<b>marantz®</b> <b>SERVICE BULLETIN</b>		Date: 15-May-2003	Model: SR5200/SR6200/SR7200
		Page: 1/2	REF.NBR: MZ02-033
Circulation:		Subject:	
Application:		Hum noise can be heard from Headphone out.	
x for information customer complaint in case of service mandatory			
		See below

<b>marantz®</b> <b>SERVICE BULLETIN</b>		Date: 15-May-2003	Model: SR5200/SR6200/SR7200
		Page: 1/6	REF.NBR: MZ02-032
Circulation:		Application:	
x for information customer complaint in case of service mandatory		See below	
		Subject:  Pop noise	
		Int.ref:

<b>marantz®</b> <b>SERVICE BULLETIN</b>		Date: 15-May.-2003	Model: SR5200,SR6200,SR7200
		Page: 1 / 1	REF.NBR: MZ02-027
Circulation:		Subject: Video synchronization problem.	
Application:		Int.ref:	
x for information customer complaint in case of service mandatory .....		See Below

<b>marantz®</b> <b>SERVICE BULLETIN</b>		Date: 27-Sep-01	Model: SR5200/6200/7200
		Page: 1/2	REF.NB MZ01-016
Circulation:		Application:	
x for information customer complaint in case of service mandatory .....		<b>Refer to following.</b>	
		Subject:  The noise (stripes) occur on the picture.	
		Int.ref

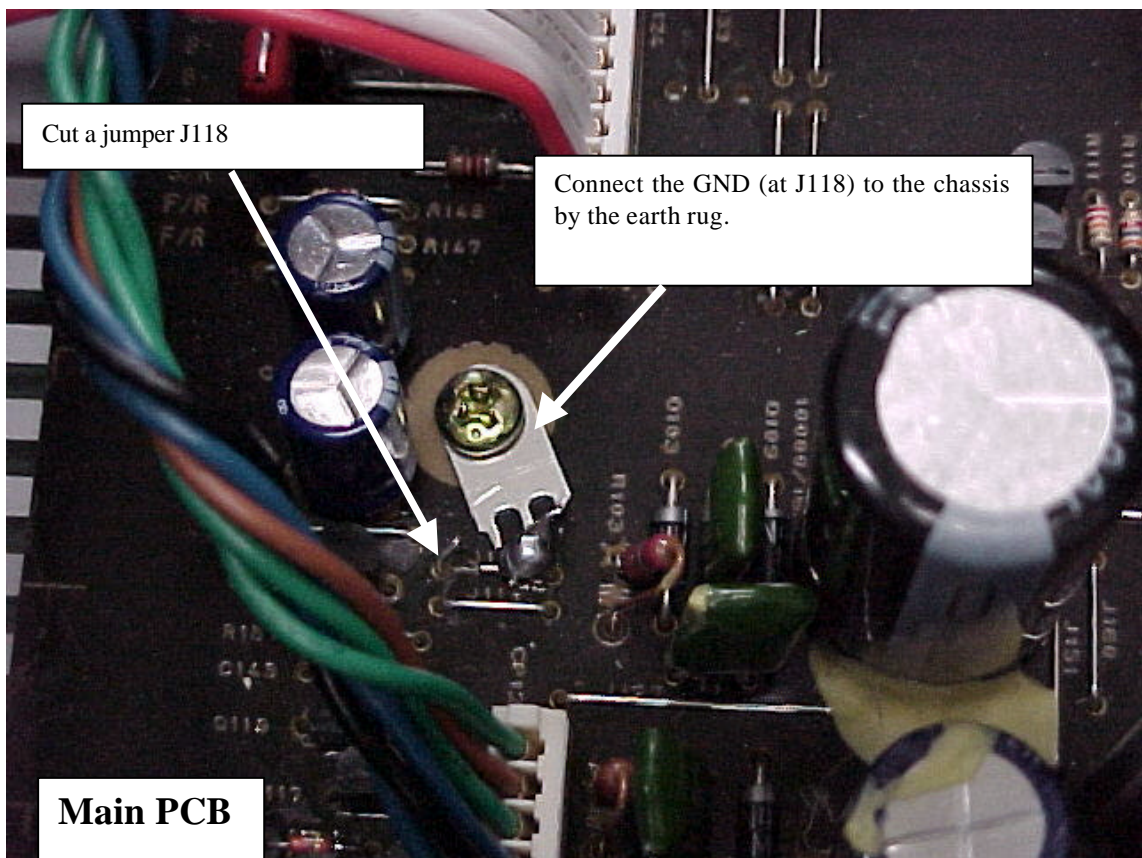
Hum noise can be heard from Headphone out

Caused by ground loop of the headphone out.

Please apply the following solution.

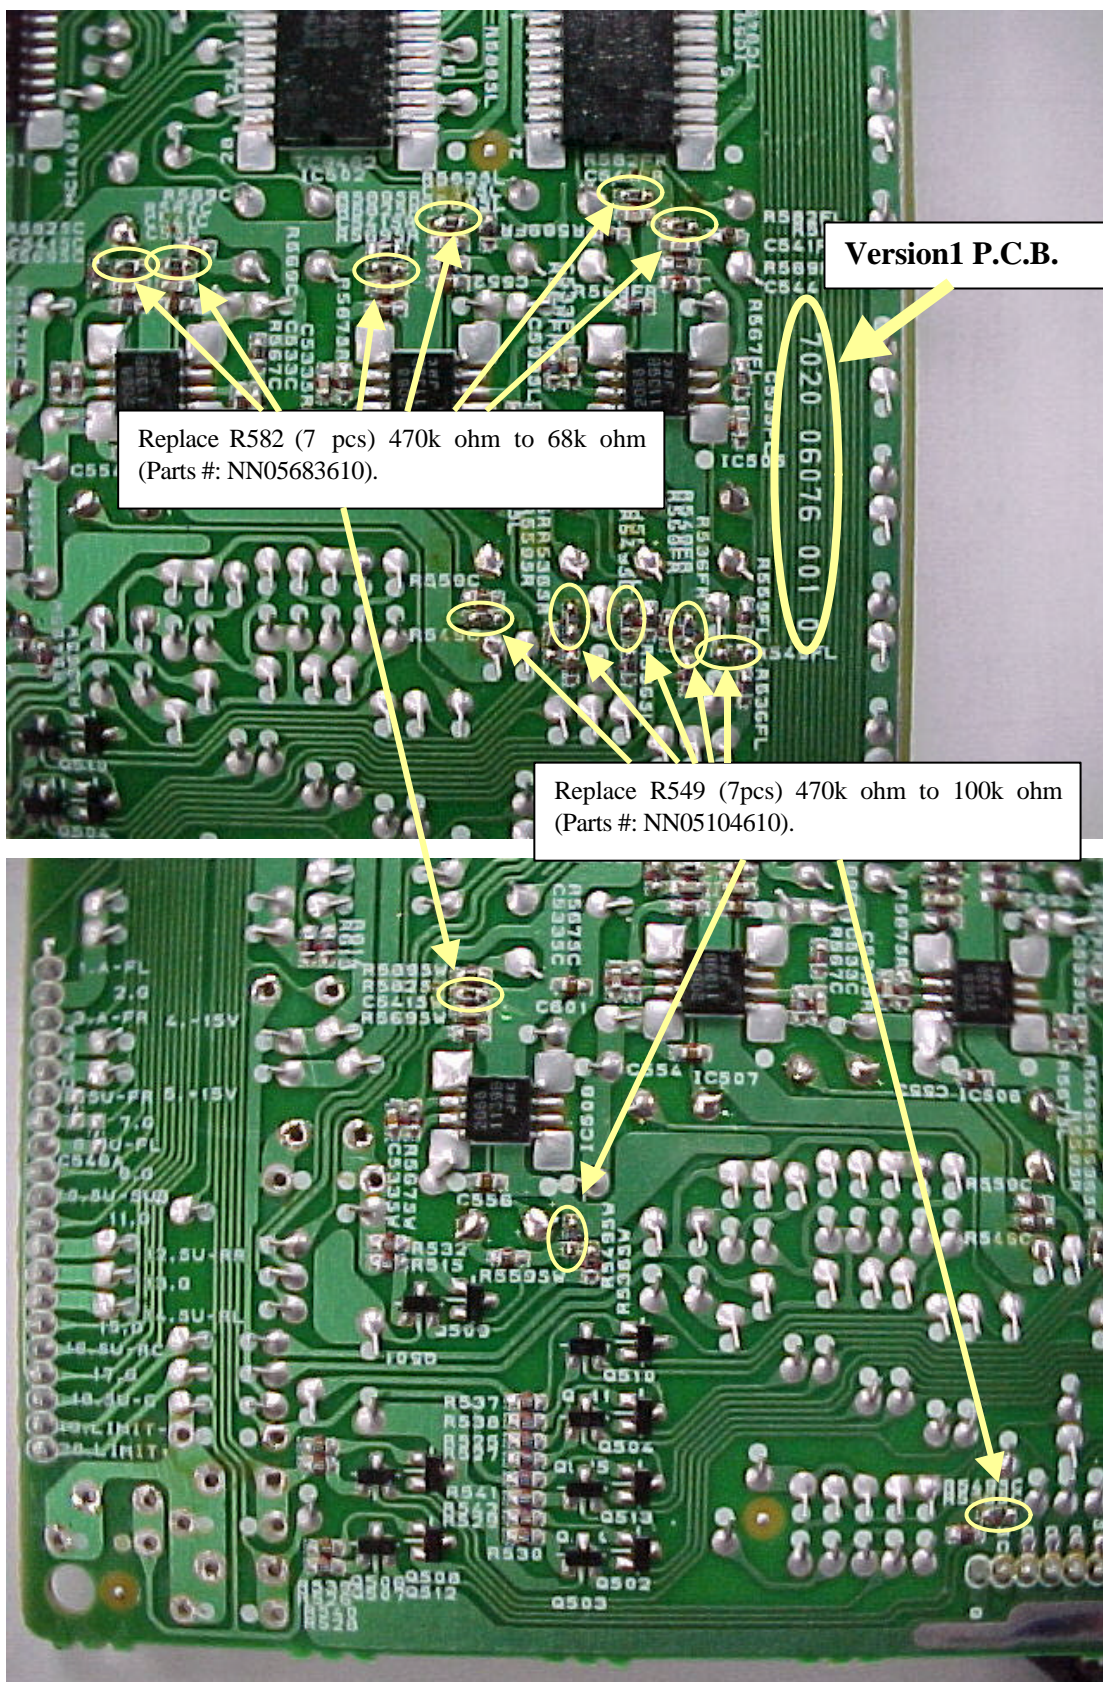
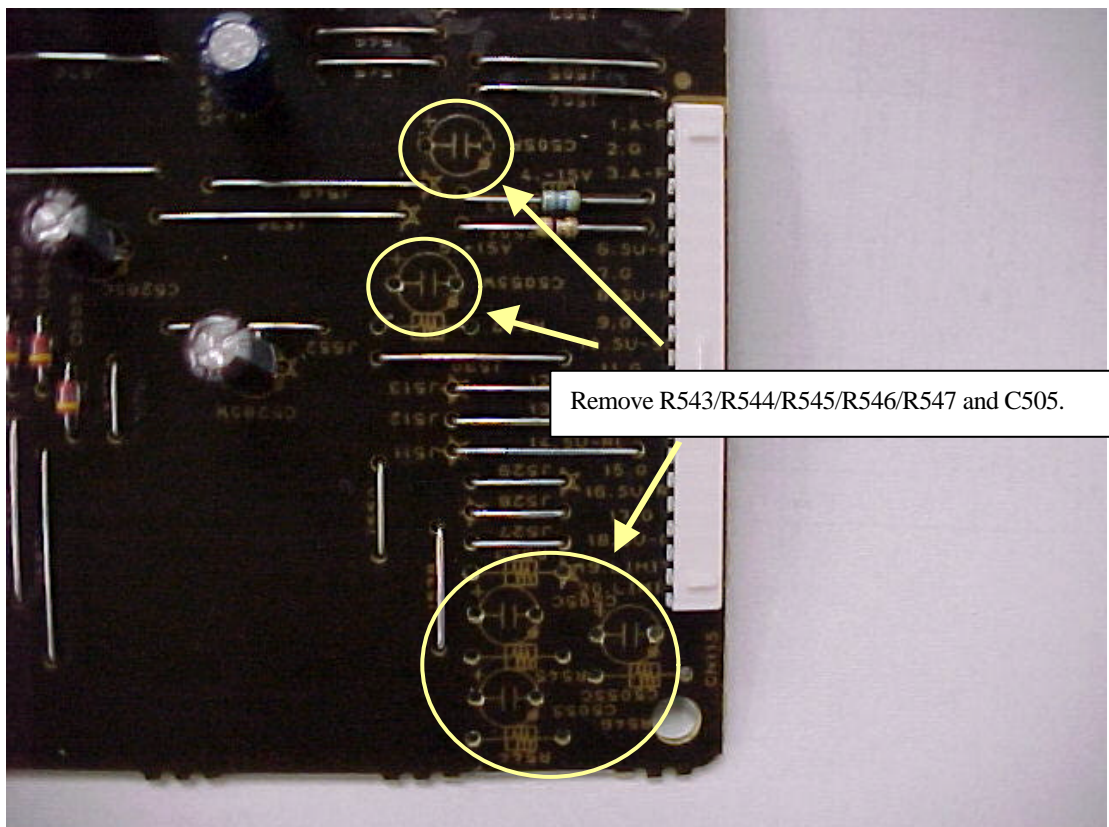
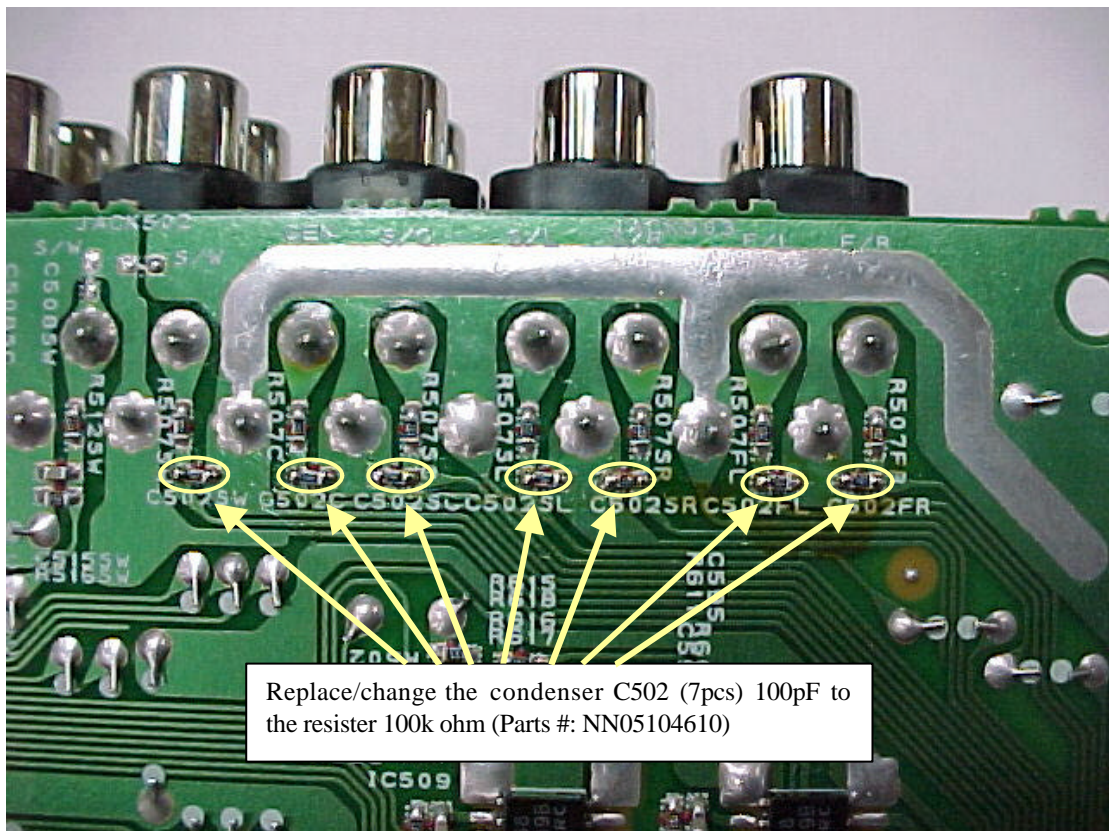
Pop noise appears when stop playing or track skip on CD playback with Digital connection.  
Pop noise appears in the condition of the Main volume is changed 74dB to 75dB(Mute) .

\* Version 1 P.C.Board (7020 06076 001-0) : Please apply the modification mentioned on Page2 to 4.

\* Version 1 P.C.Board (7020 06076 001-0) : Please apply the modification mentioned below (Page2 to 4).

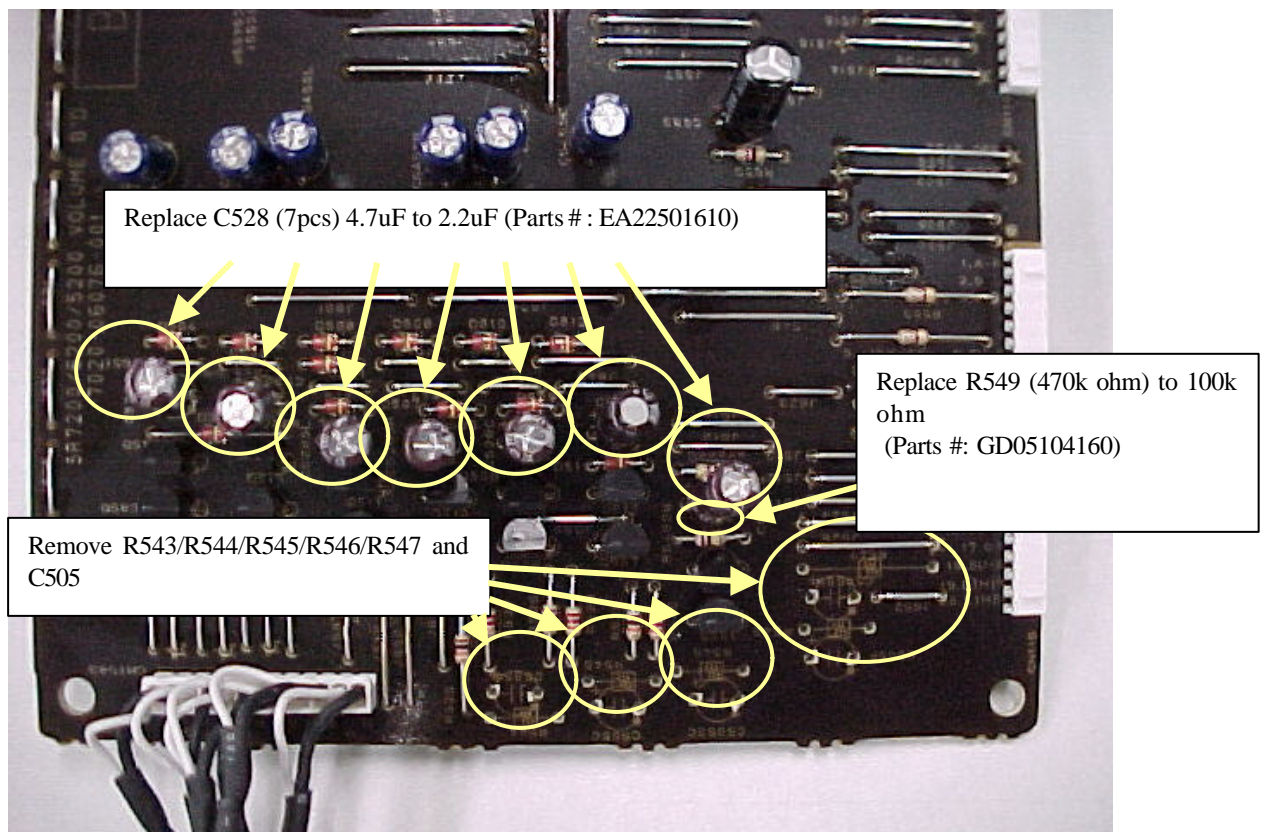
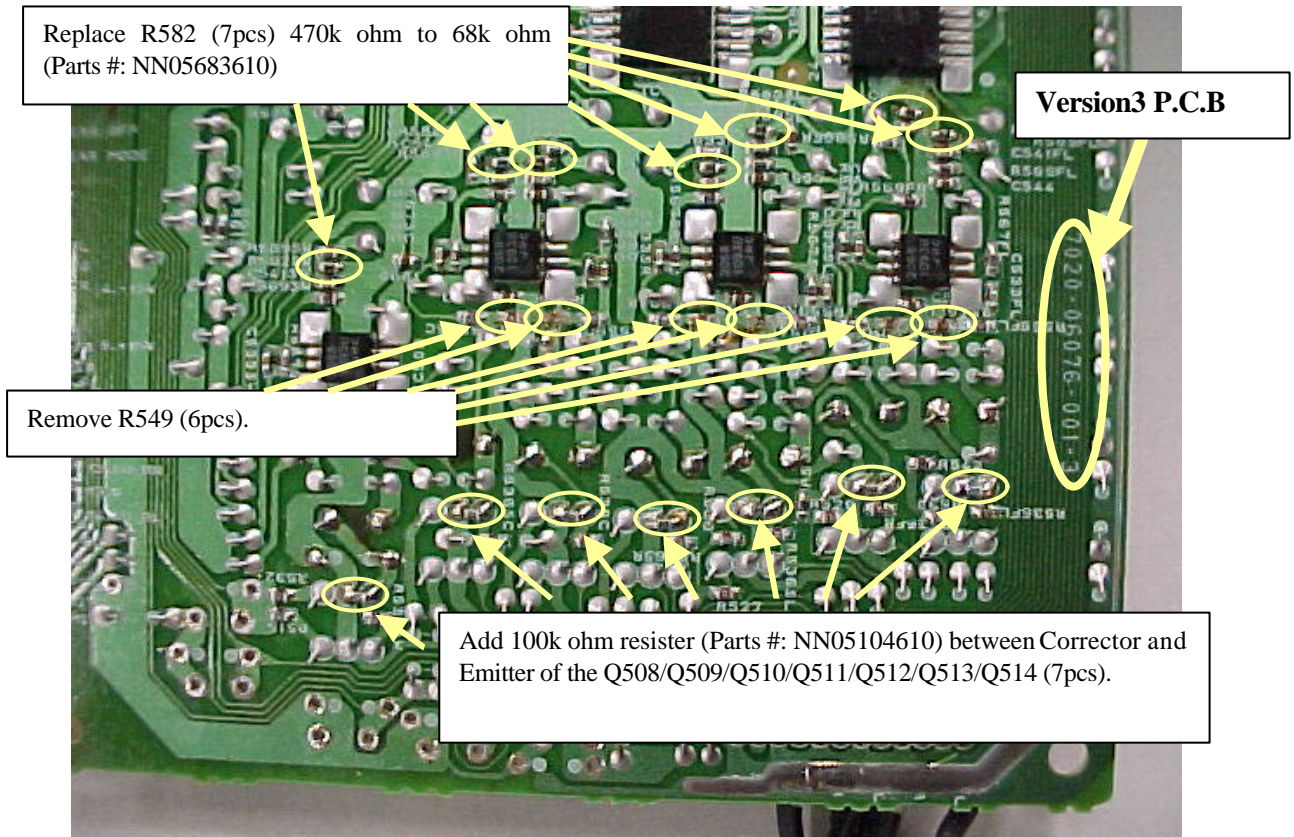
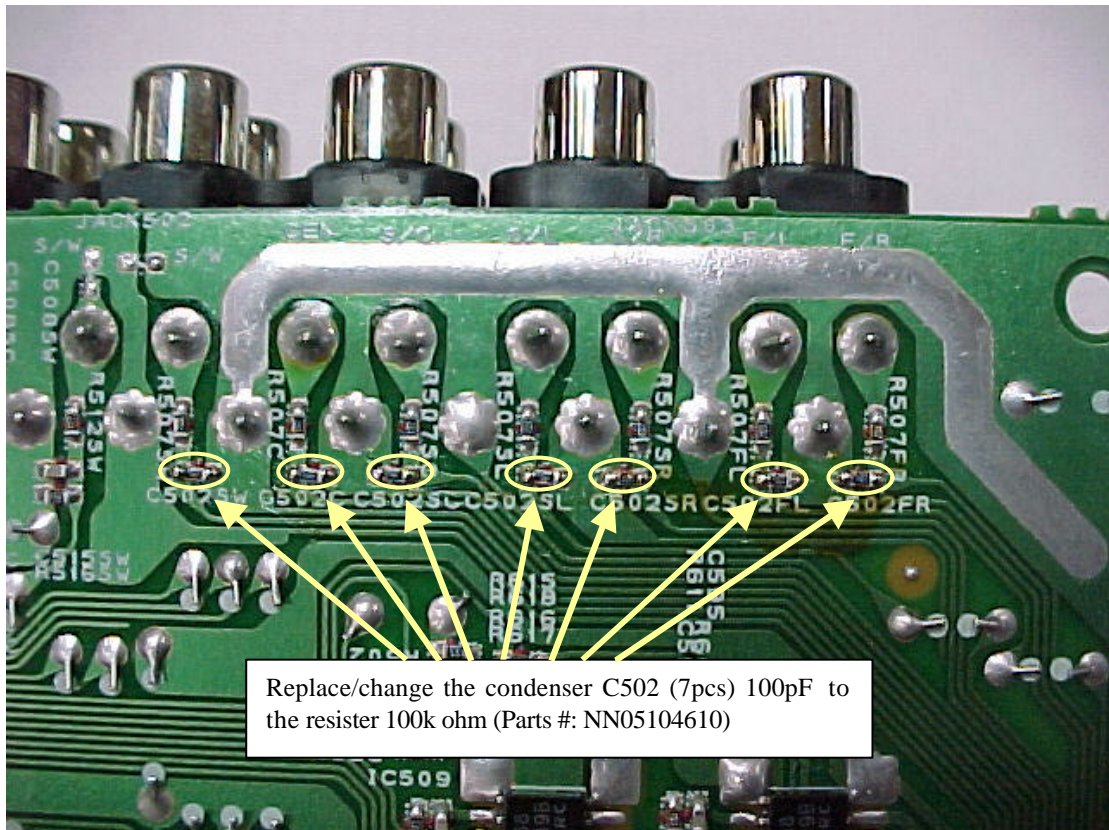
\* **Version 3 P.C.Board (7020 06076 001-3)** : Please apply the modification mentioned below (Page 5 to 6).

Replace/change the condenser C502 (7pcs) 100pF to the resistor 100k ohm (Parts #: NN05104610)

PIC.01

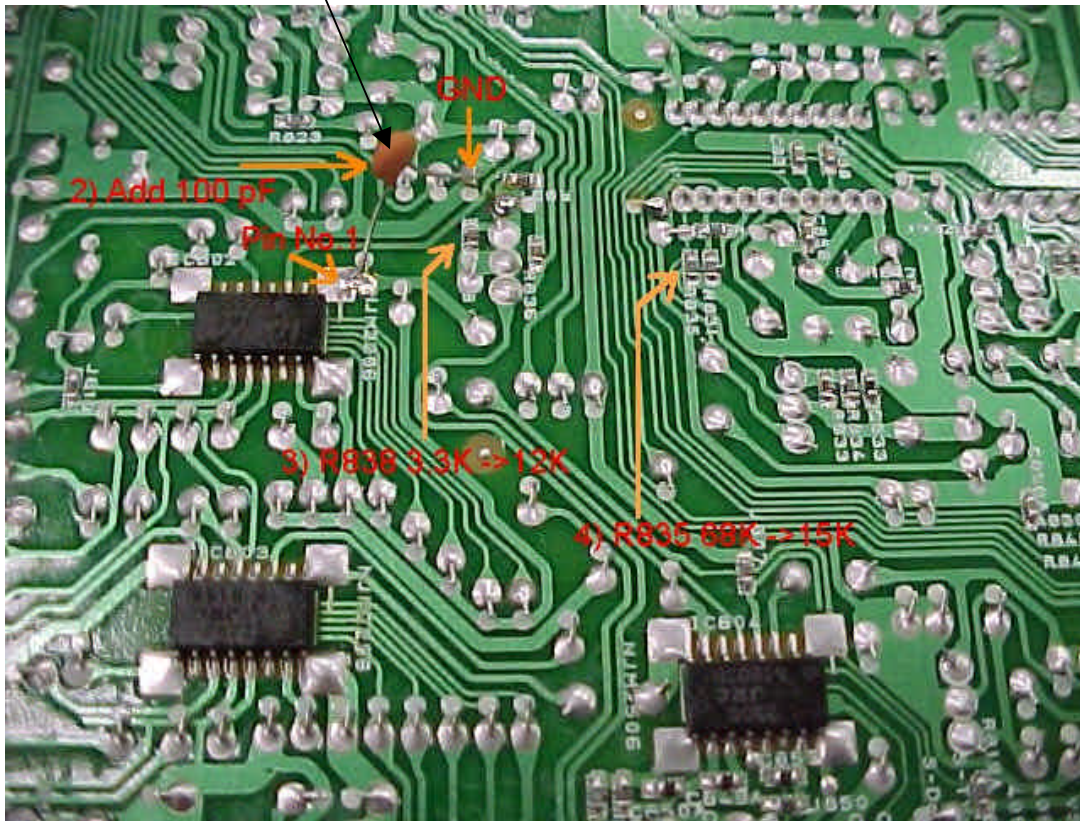
- 1) The capacitor(C810A 100pF: DK16101300 4822 122 33195) is added between 1P of IC802 and GND(refer to PIC.01).
- 2) The jumper wire(J841) is deleted and a capacitor(C840A 47uF/16V: EA47601620 9965 000 06289) is added to same position (refer to PIC.02).
- 3) The chip resistor(R838) is changed into 12kohm one(NN05123610 4822 051 30123) from the present 3.3kohm one.
- 4) The chip resistor(R835) is changed into 15kohm one(NN05153610 4822 051 30153) from the present 68kohm one.

C810A (100pF: DK16101300

4822 122 33195)
